ADDENDUM NO. 3

RE: HIGH SCHOOL #13

High School #13

Howard County Public School System
Bid Number: 016.20.B4

2 SECTION THRU CHILLER ENCLOSURE
A-530 SCALE: 1/2" = 1'-0"

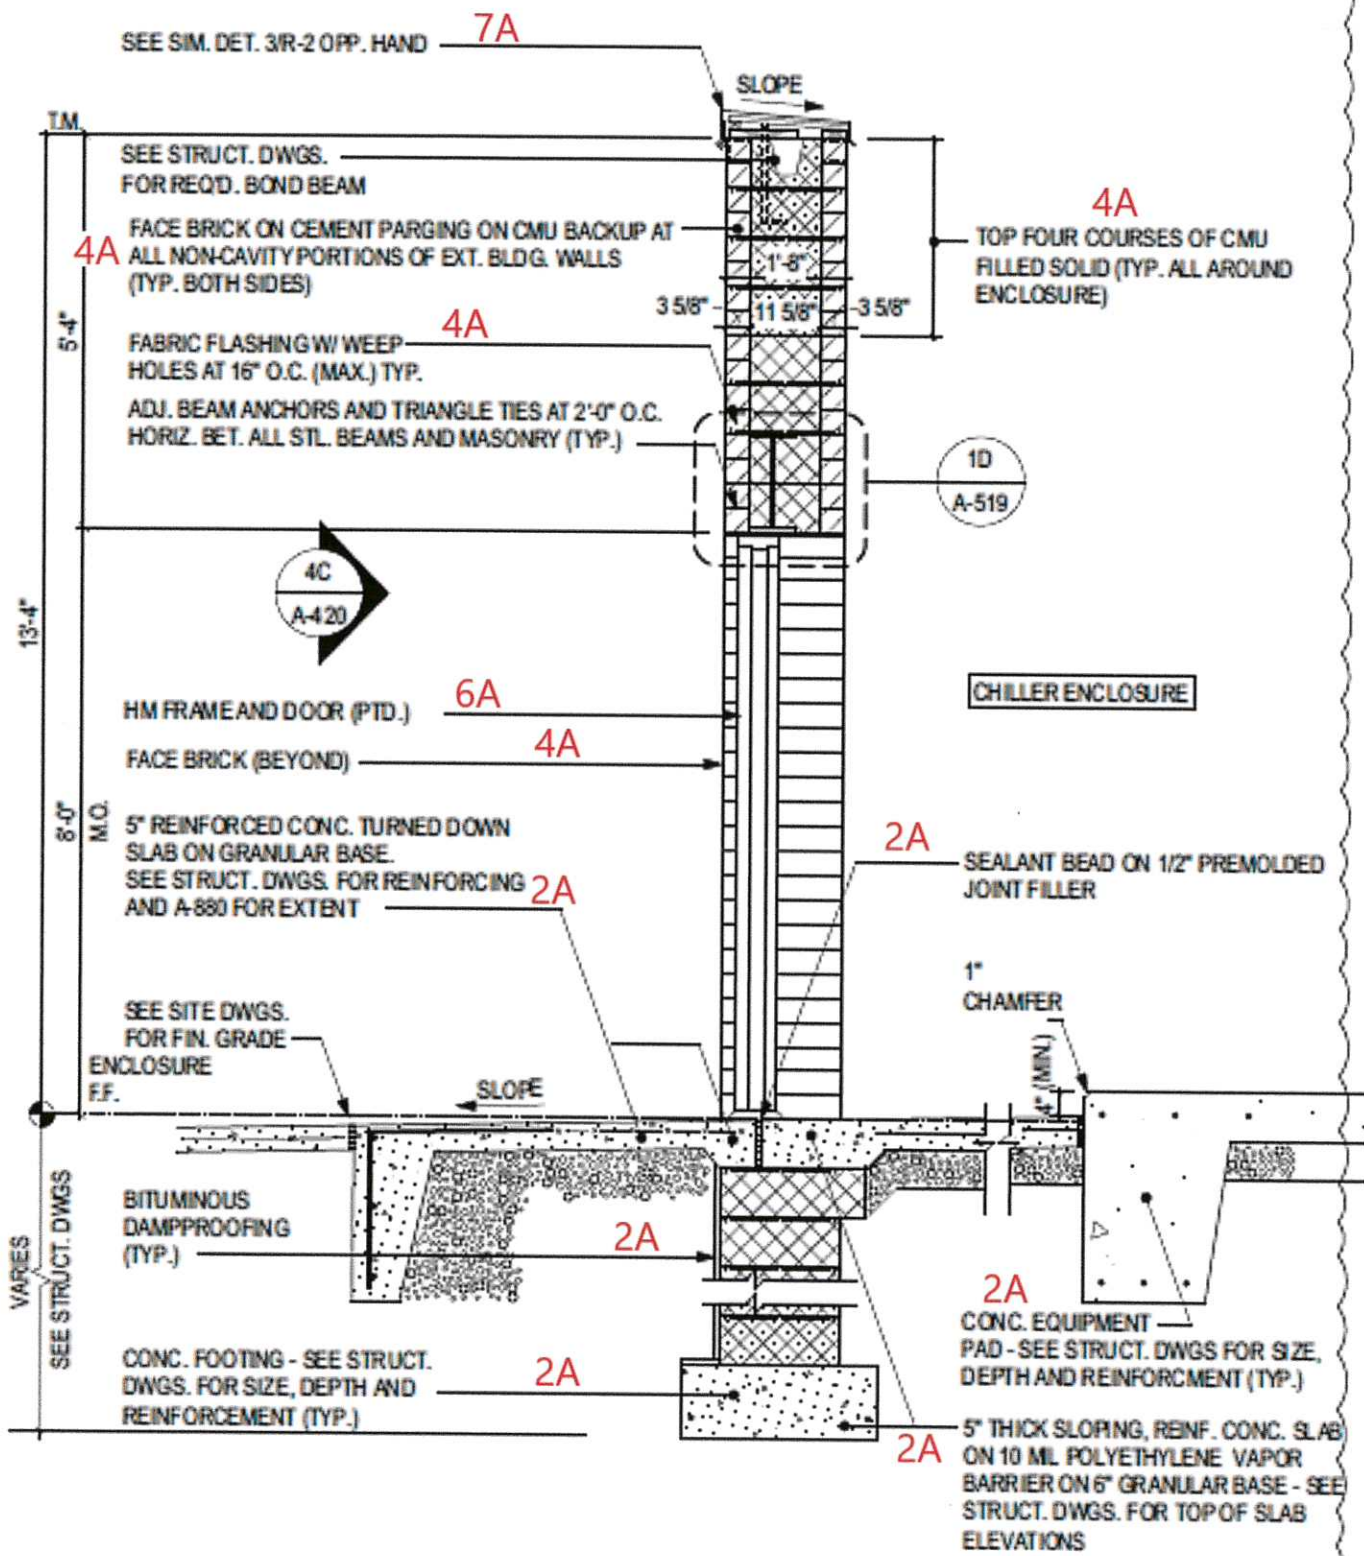
REPLACE Detail 2/A-530 SECTION THRU CHILLER ENCLOSURE as shown on attached sketch ADD_3_A2, dated 18 February 20.
